PRELIMINARY/FINAL DRAINAGE REPORT FOR HIGH PLAINS FILING NO. 1

SP-18-003
SF-18-024

PRELIMINARY/FINAL DRAINAGE REPORT
HIGH PLAINS FILING NO. 1

CULVERT STAGE-DISCHARGE SIZING (INLET vs. OUTLET CONTROL WITH TAILWATER EFFECTS)

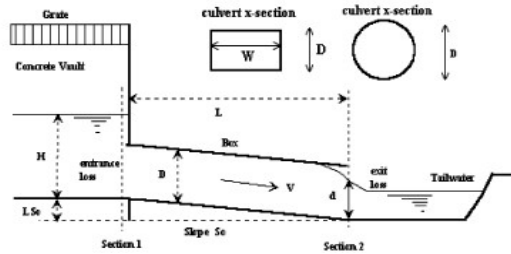
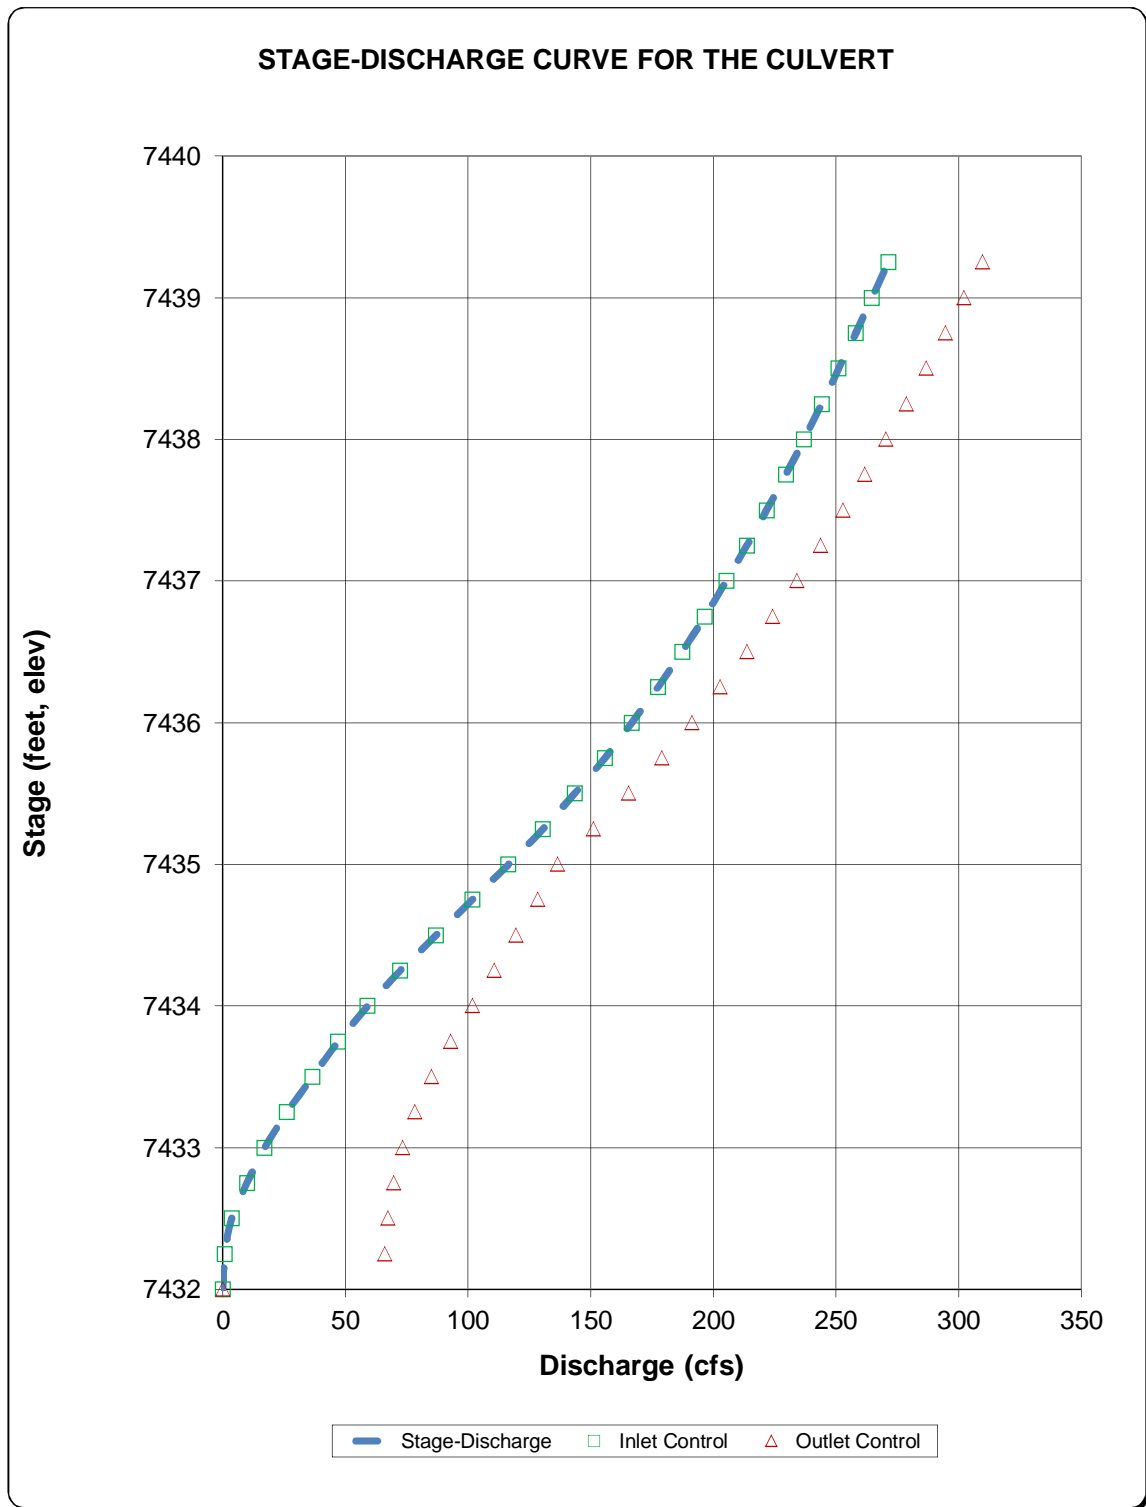
1. Culvert P&P is missing in the construction drawings. Culvert calculation will be reviewed with the resubmittal.
2. Submit the outlet protection calculation
3. Provide the Hw/D. Per DCM Hw/D must be less than 1.5.
4. Provide the culvert calculation for the proposed 30" RCP.

EXISTING CONDITIONS

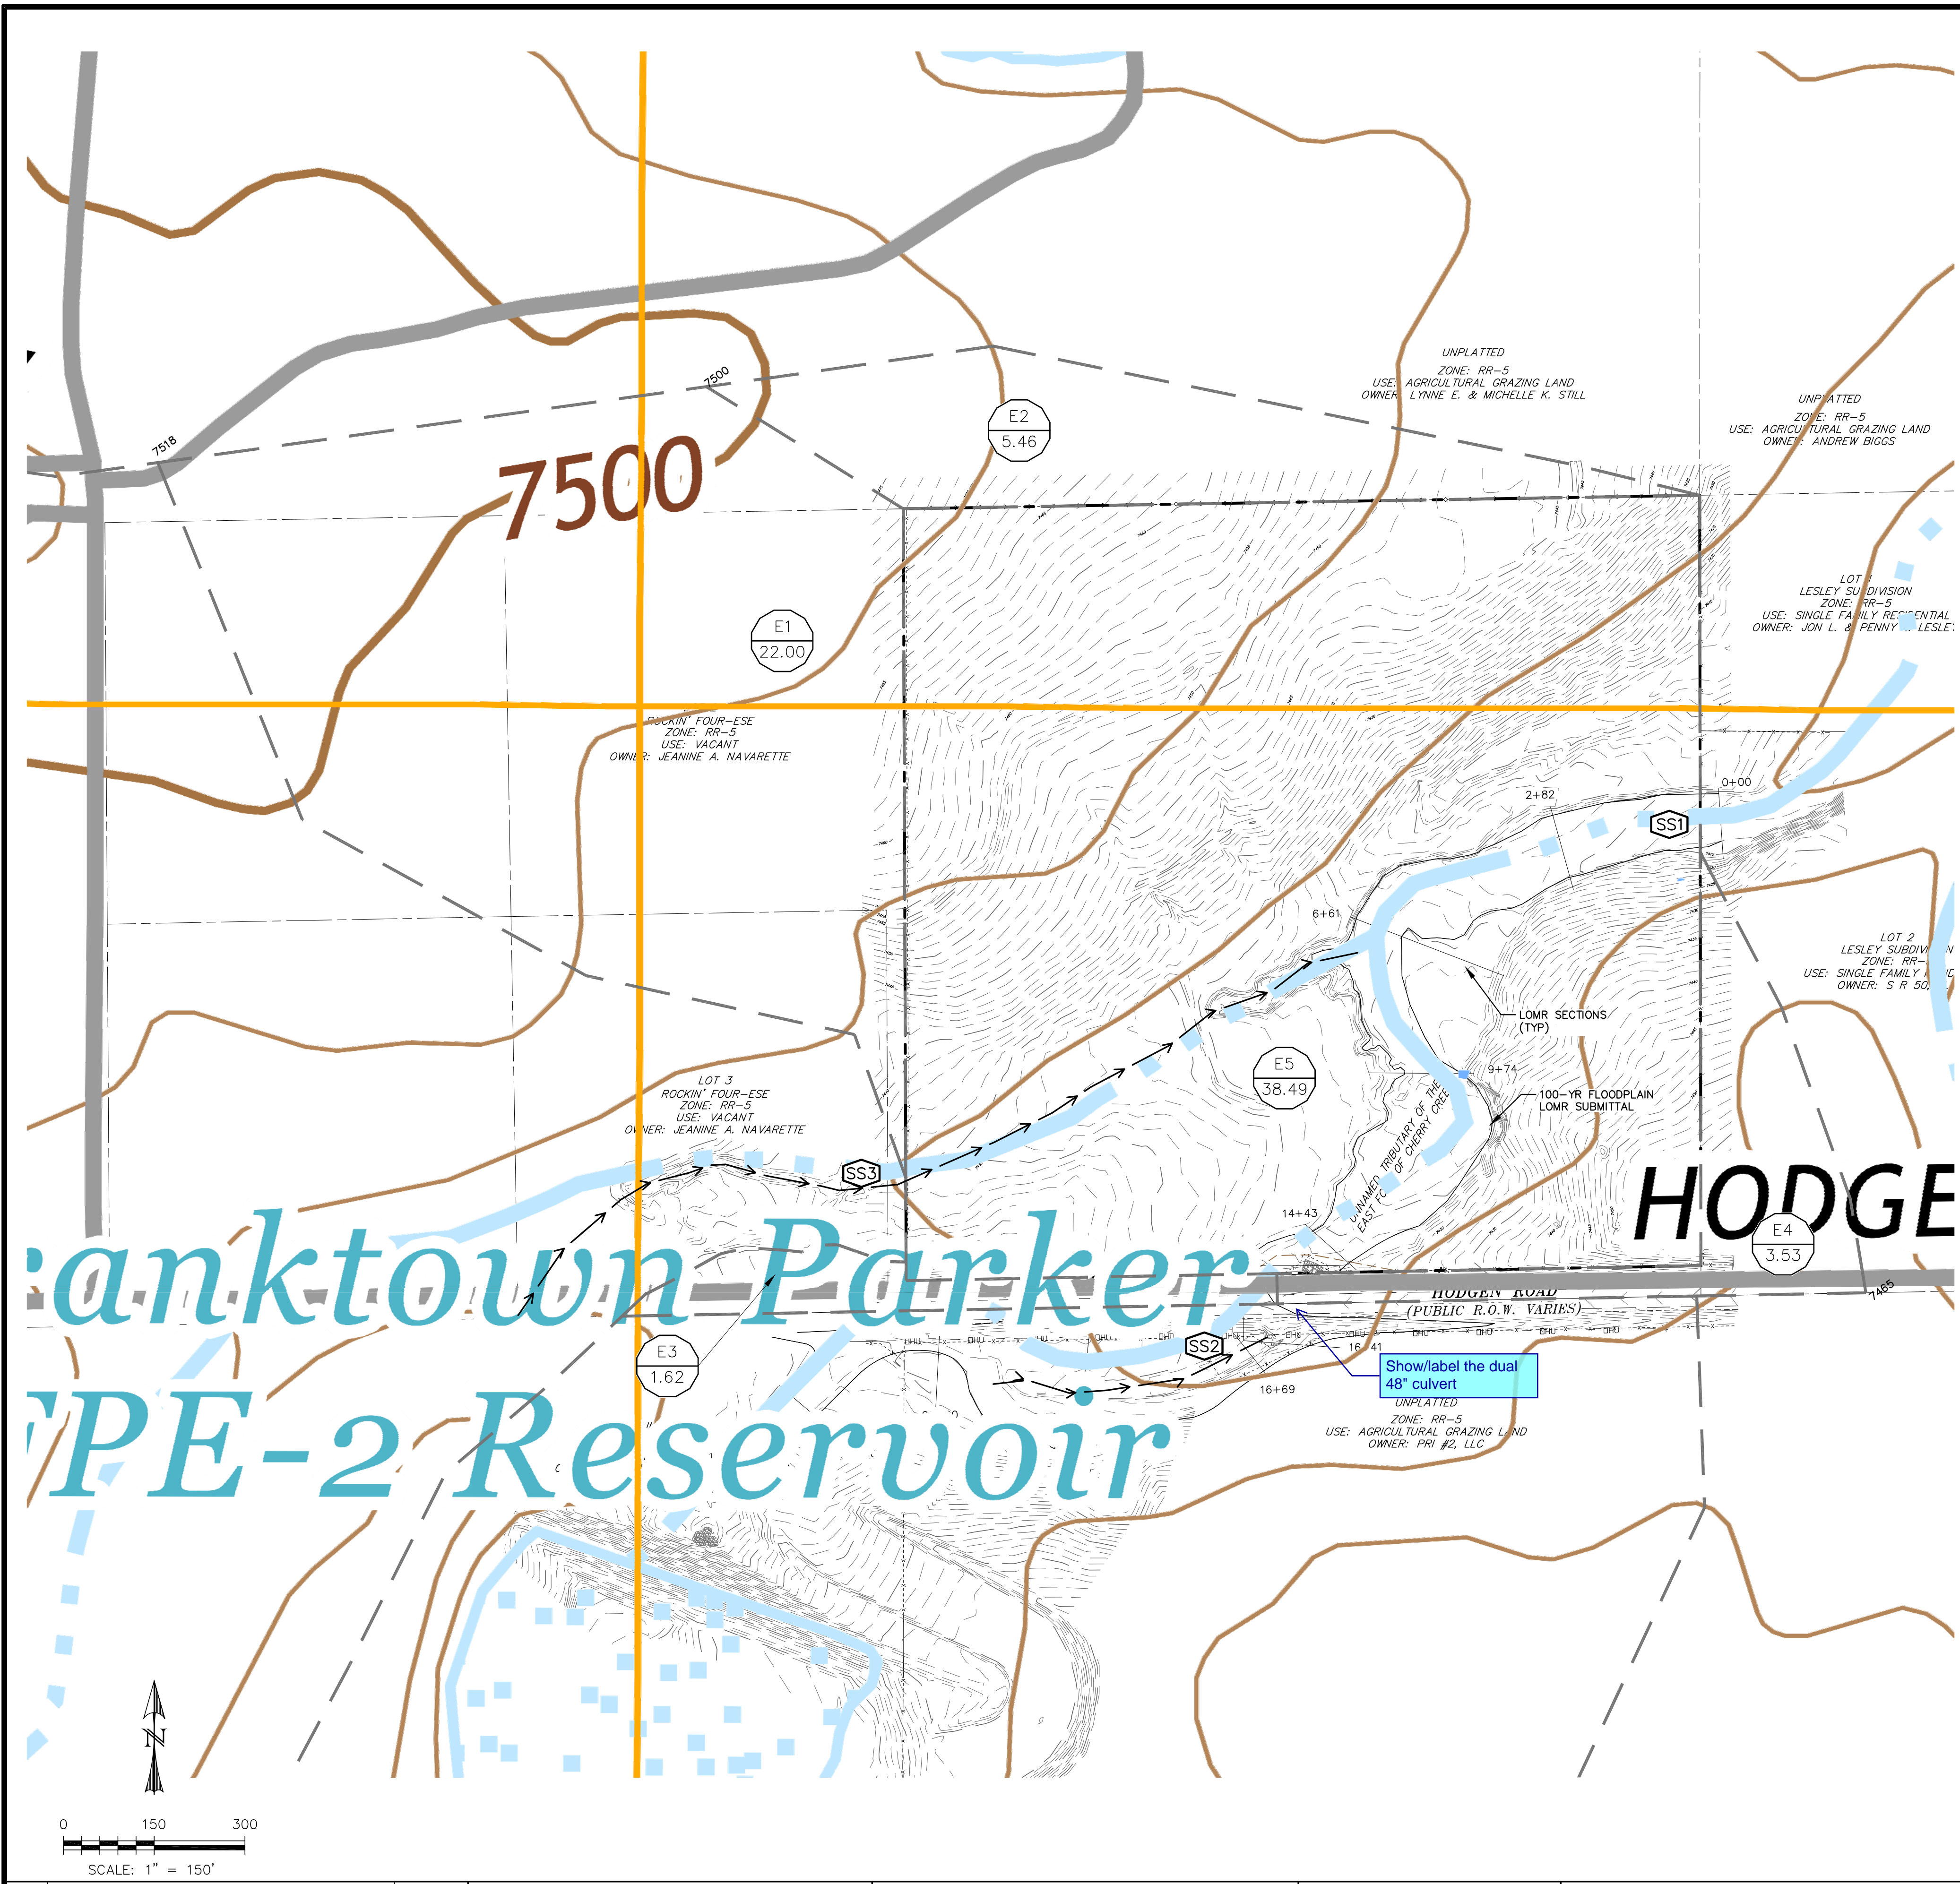
Show/label the dual
48" culvert

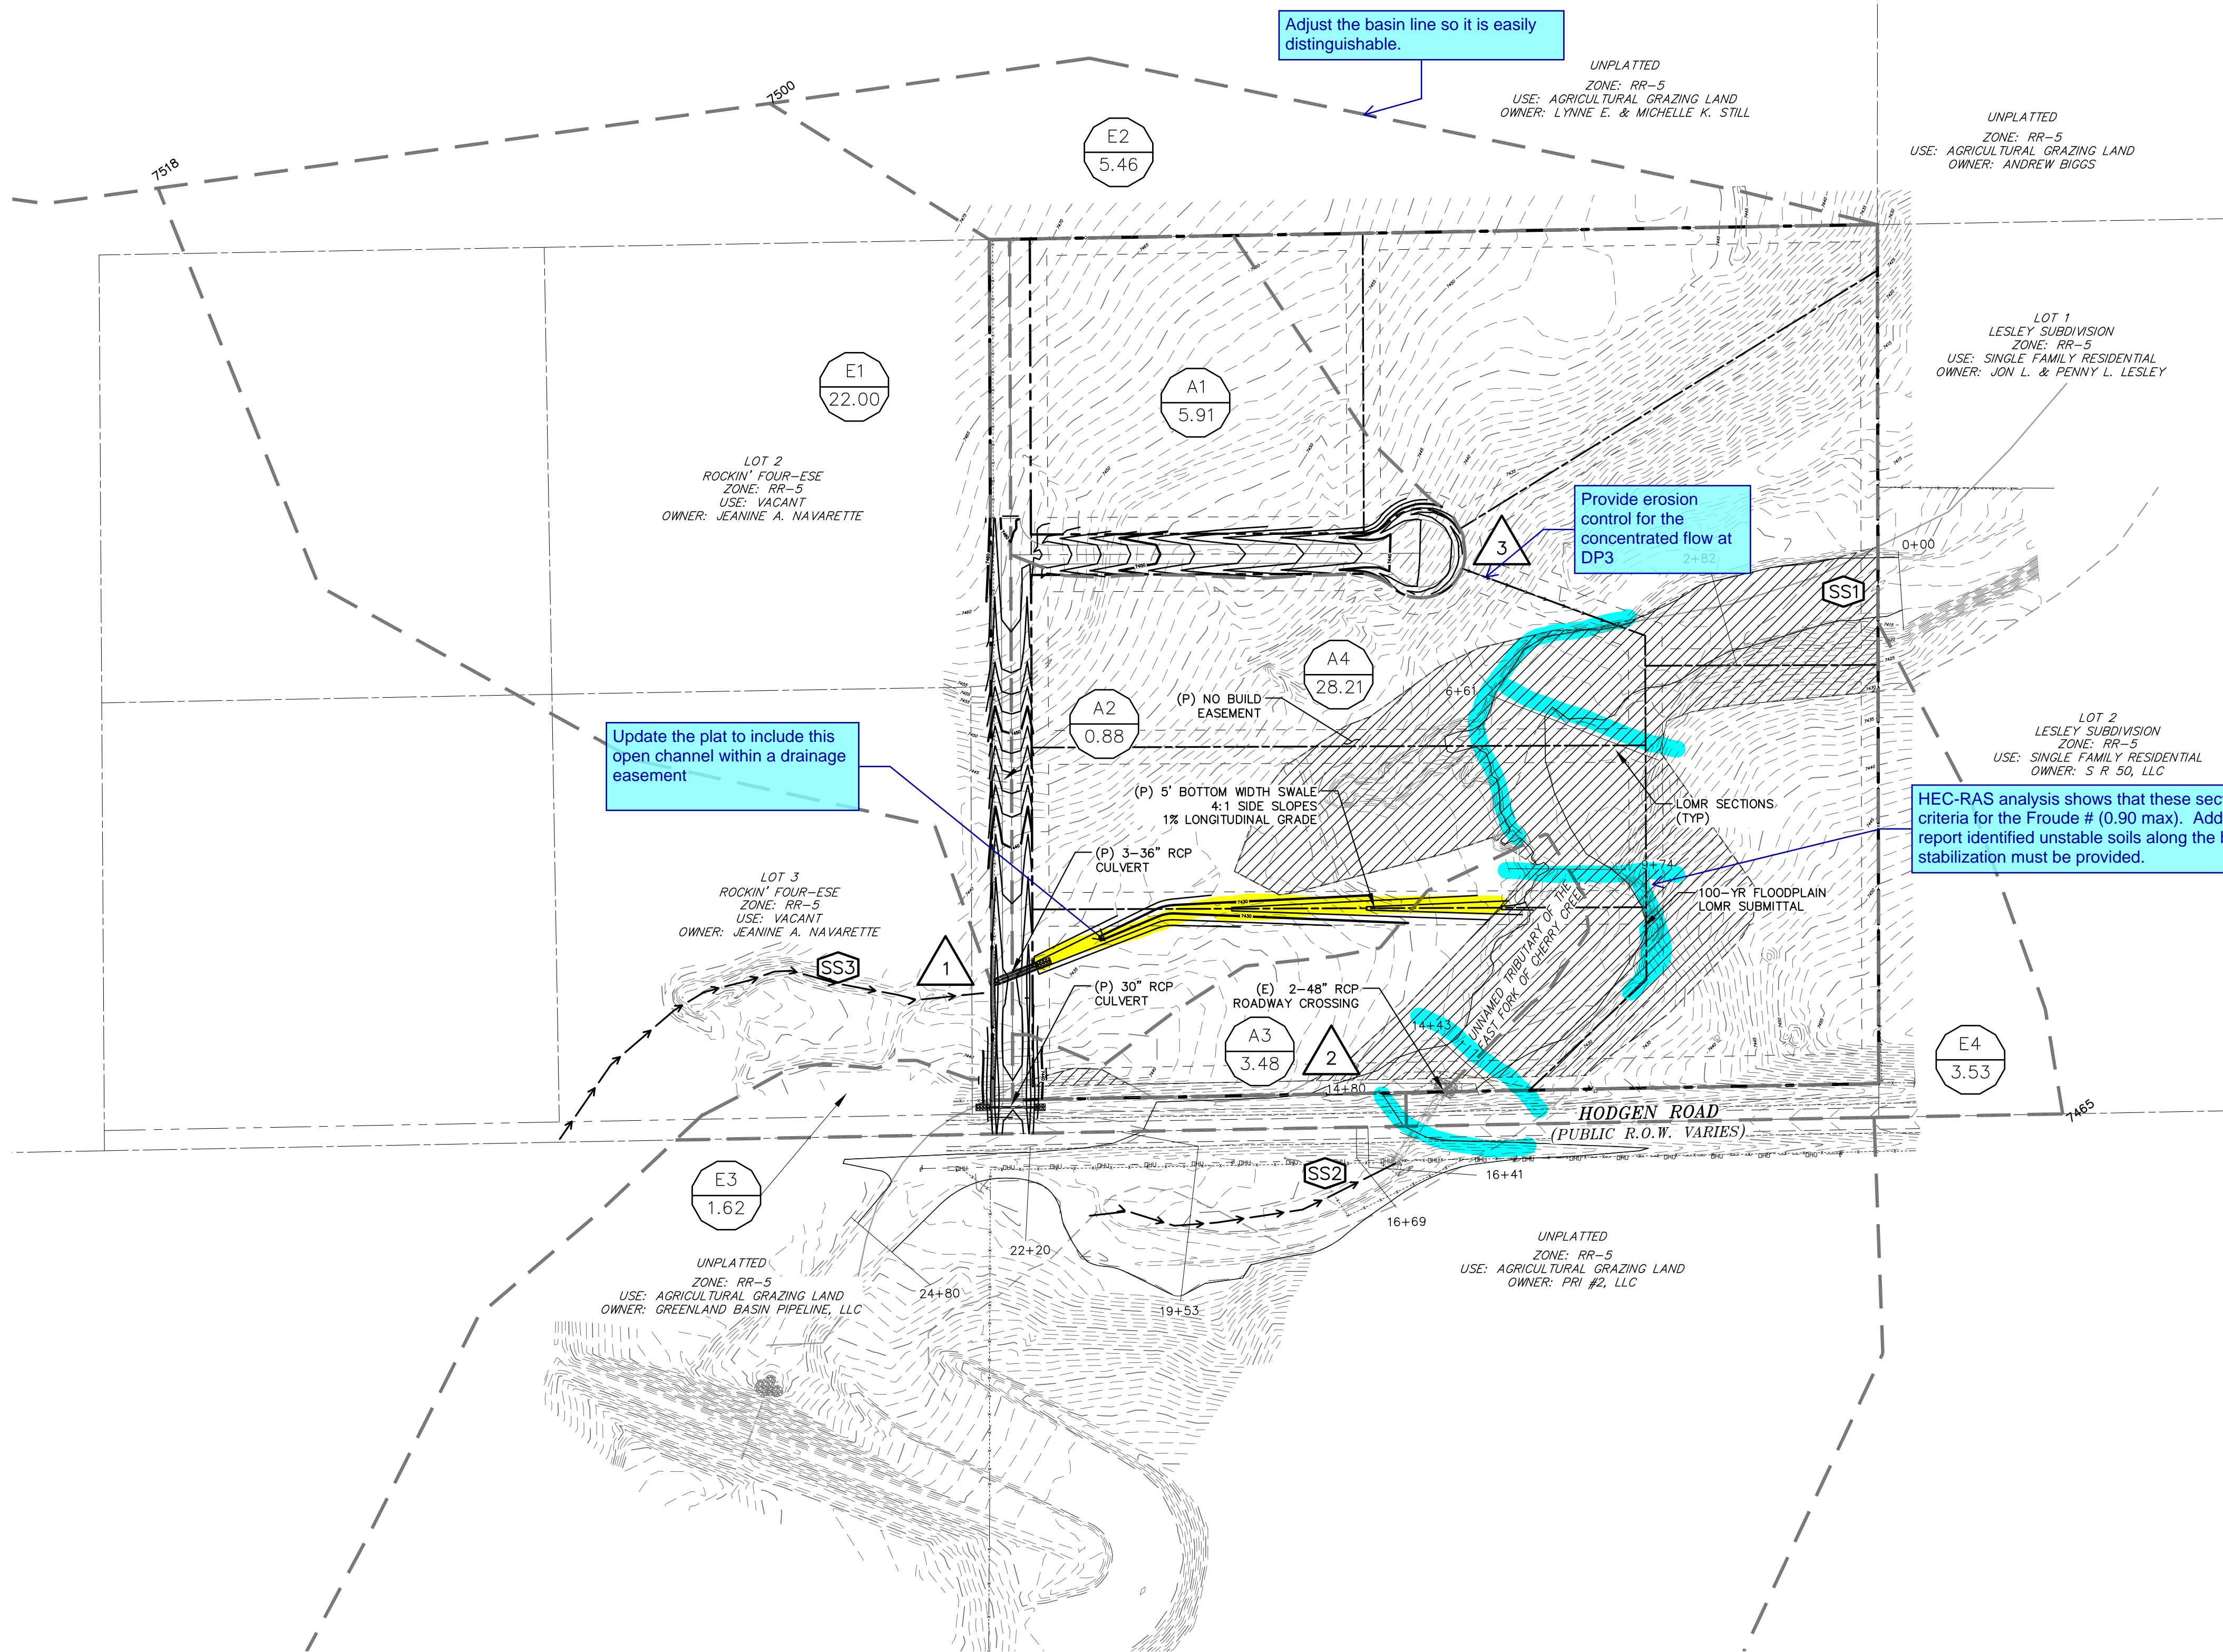
Provide erosion control for the concentrated flow at DP3
